DART AEROSPACE LTD		Work Order: 105217
Description: Crosstube Assembly, Mid Aft		Part Number: D206-667-247TRN
Inspection Dwg: D206-667-247 Rev: A		Page 1 of 2

DRAWING NO. D206-667-247
TITLE CROSSTUBE ASS'Y (206L MID AFT)

DRAWING NO. D206-667-247	TITLE CROSSTUBE ASS'Y (206L MID AFT)	REV. A	DART AEROSPACE LTD ENGINEERING ORDER		D.E.O. NO. D206-667-247-A-1	SHEET NO: SHEET 1 OF 1	SCALE NTS
DRAWN 90	CHECKED ASS	MFG. APPR. KTB	APPROVED JMD		DE APPR. H		
DATE 11.07.15	DATE 11.07.20	DATE 11.07.21	DATE 11/07/21		DATE 11.07.21

REPLACE MAGNOBOND WITH PROSEAL.

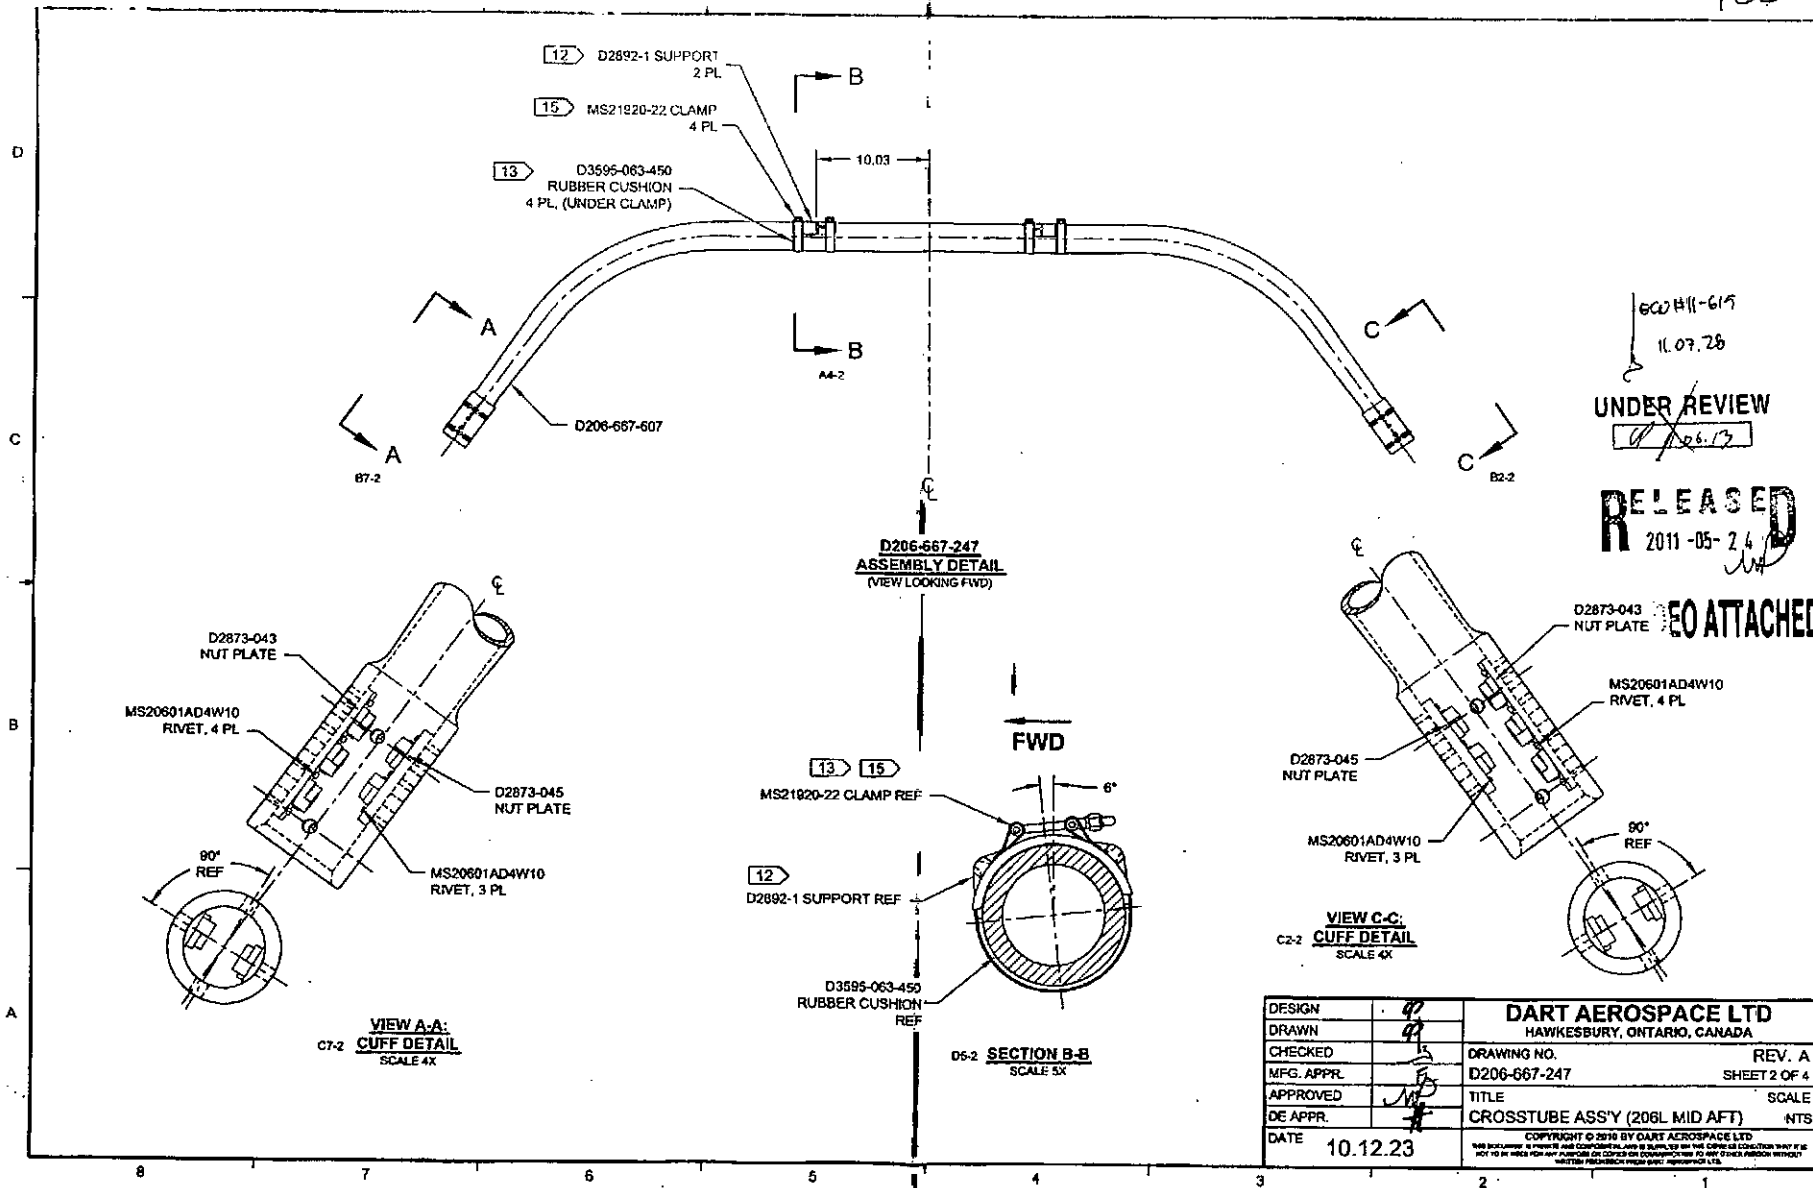
PURPOSE:

Item	Qty -247	Part Number	Description
9	A/R	PROSEAL 890 B-2	SEALANT, AMS-S-8802 CLASS B-2

9	A/R	MAGNOBOND 6398	ROCKWELL SPECIFICATION RBO-120-023 ADHESIVE (TEXTRON/BELL SPEC. 289-947-100, TYPE II, CLASS 2 ADHESIVE)
---	-----	----------------	---

NOTE 12 & 15, SHEET 1 IS AMENDED AS FOLLOWS:

- 12) TO INSTALL D2892-1 SUPPORT: ABRASE MATING SURFACE OF SUPPORT AND CROSSTUBE WITH 180-GRIT SANDPAPER AND REMOVE RESIDUE WITH MEK (OR EQUIVALENT). APPLY A 0.04" TO 0.07" THICK LAYER OF PROSEAL 890 CLASS B-2 (OR AMS-S-8802 CLASS B-2) SEALANT TO MATING SURFACE OF SUPPORT.
- 15) TORQUE CLAMPS 80 TO 100 IN-LB. ENSURE AT LEAST 1.5 THREADS SHOWING IN SAFETY AND THAT NUT HAS NOT BOTTOMED-OUT AFTER TORQUING. **PRIOR TO PACKAGING, RE-CHECK TORQUE ON CLAMPS AFTER PROSEAL 890 SEALANT HAS CURED FOR 72 HOURS.**

- 12) INSTALL D2892-1 SUPPORT USING 0.03" TO 0.06" THICK LAYER OF MAGNOBOND 6398 PER QSI 015. LET CURE FOR 12 HOURS AFTER INSTALLATION AND PRIOR TO PACKAGING.
- 15) TORQUE CLAMPS 80 TO 100 IN-LB. ENSURE AT LEAST 1.5 THREADS SHOWING IN SAFETY AND THAT NUT HAS NOT BOTTOMED-OUT AFTER TORQUING.
